RE: Old Arcata Road Rehabilitation and Pedestrian/Bikeway Improvements Coastal Development Permit; Bayside area; record Number PLN - 2022 - 17654 (filed 02/28/2022)

RE: Old Arcata Road Rehabilitation Project / Proposed Roundabout

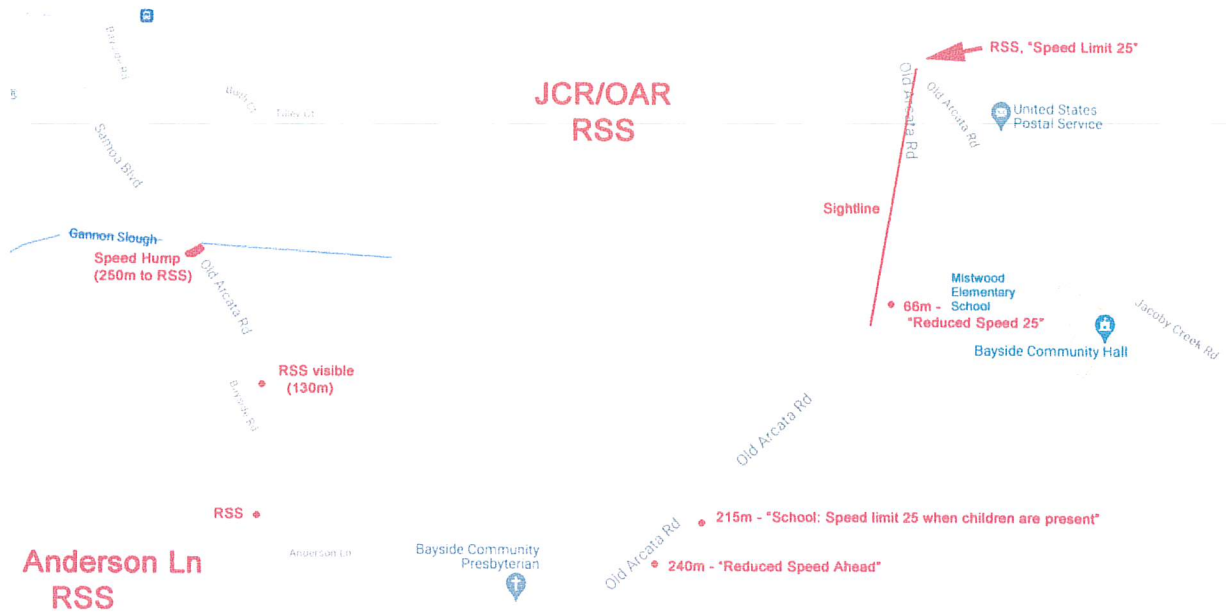
Jacoby Creek Road: Eliminating the existing stop at the westbound lane of JCR and further “cutting the corner” for northbound cars turning east onto JCR will allow vehicles in those lanes to travel faster than at present (significantly so for westbound cars on JCR, going from a stop sign to c. 20-25mph). Vehicles southbound on OAR that turn east onto JCR will probably not change their maximum (i.e., when no other cars are present) speed much; since they wouldn’t need to wait (as much) for northbound cars to pass, their overall average speed would presumably increase slightly. The roundabout would prevent cars turning from OAR onto JCR from swinging wide into the oncoming lanes, which is a genuine problem there. *It is not clear that increasing speeds at the western end of Jacoby Creek Road, with entries to the Community Hall, Mistwood Elementary, Stream Guys and the Post Office all within 120m of the intersection, will improve safety on JCR. The problem of swinging wide onto JCR can be fully addressed with a mountable median island, as planned in Alternative 2.*

Southbound Old Arcata Road: Anecdotally, some vehicles do begin the transition to a 45mph speed limit before they arrive at the intersection. However illegal, it isn’t clear how much of a safety problem this is as long as they don’t begin the increase too far north of the intersection. In any case, *because the proposed roundabout is off-center, this southbound lane is minimally affected by the curve and is unlikely to physically constrain vehicles to below 30-35mph.*

Northbound Old Arcata Road: This is the main target of the project, and a roundabout would presumably physically force vehicles to obey the reduction in speed limit from 45mph to (under) 25mph. This is a worthy goal. Implicit in the proposal is the idea that “signage hasn’t solved the problem, so we need a physical obstacle to speeding”; the problem is that the existing speed limit transition and associated signage is in totally the wrong place, and so does not represent a failure in principle – only in execution. *The City should attempt to solve the problem with appropriate signage before committing to an expensive roundabout that imposes significant social as well as monetary costs on the school and community hall.*

In conclusion, I support Alternative 2 for the JCR/OAR intersection, with the transition from 45mph to 25mph shifted ~240m south, and the RSS moved ~90+m south so that it would be visible for over 500m. Rumble strips at the 240m south position would alert drivers to the change without creating excessive noise for residents (it's open fields on both sides) or forcing emergency vehicles to slow down. As casual observations suggest, and my observations at the Anderson Ln RSS confirm, no matter what is done there will be some drivers who exceed the speed limit. I strongly support installing one or more radar speed cameras in the area; programmed to ONLY photograph vehicles speeding well above the limit, the only "privacy right" being challenged is the right to commit a crime and endanger community members. This is the only way that speeding on JCR and OAR can be (nearly) eliminated.
